Facility: Activity & Recreation Center

Address: 1701 W. Ash Street

Date of Survey: 03/05/10 & 03/09/10

The ARC is a health club and fitness center. This 73,000 sq. ft. facility has an indoor leisure pool, gymnasium, strength training equipment and weights, cardio equipment, indoor track, group exercise classes, etc.

ARC – Second Floor Plan

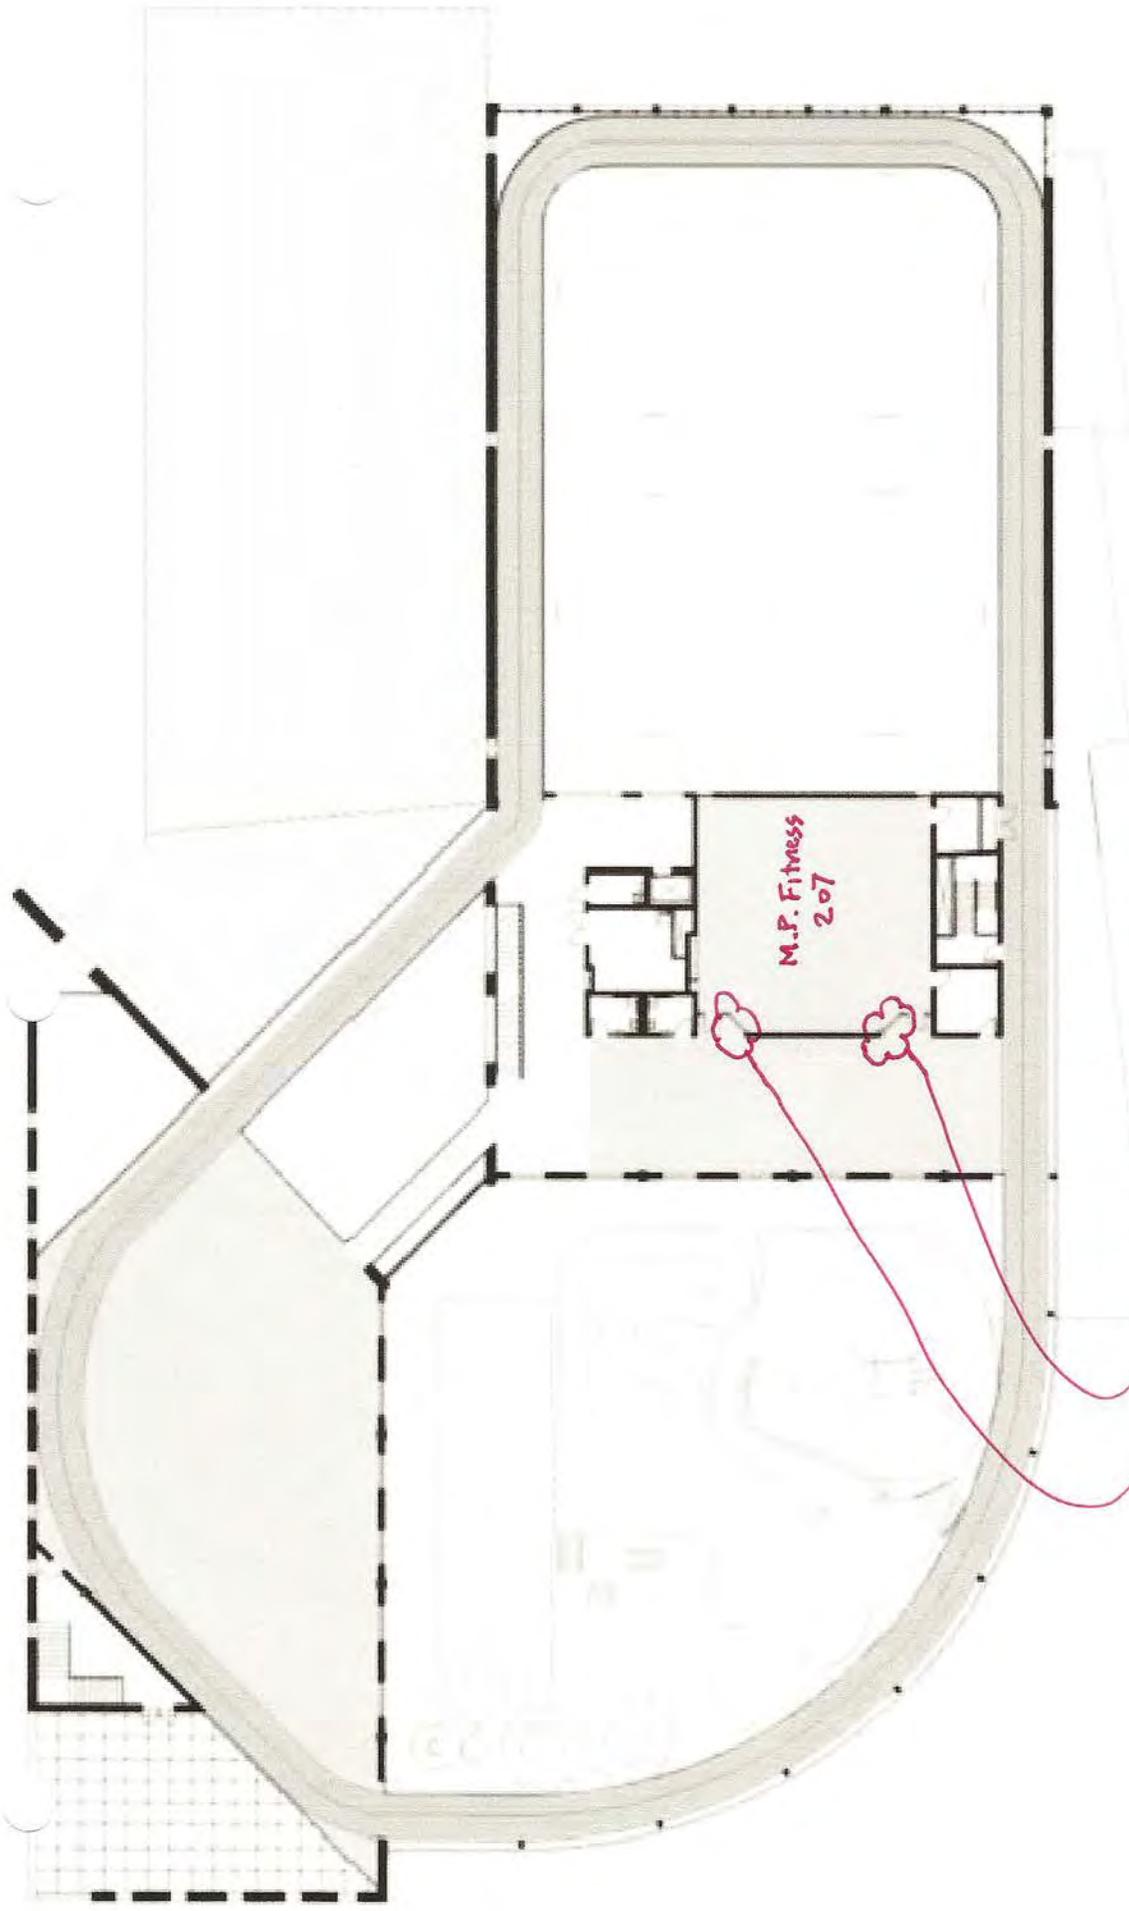
- Two doors at Multi-Purpose Fitness Room 207 do not provided minimum required latch side clearance of 18" per ADAAG 4.13.6 (16" provided). At least one of those doors should be modified to either provide the required 18" latch side clearance or install an automatic door opener. **Estimated Cost: \$489.00**

Only 16" latch side clearance provided @ these doors (min. 18" reqd.)
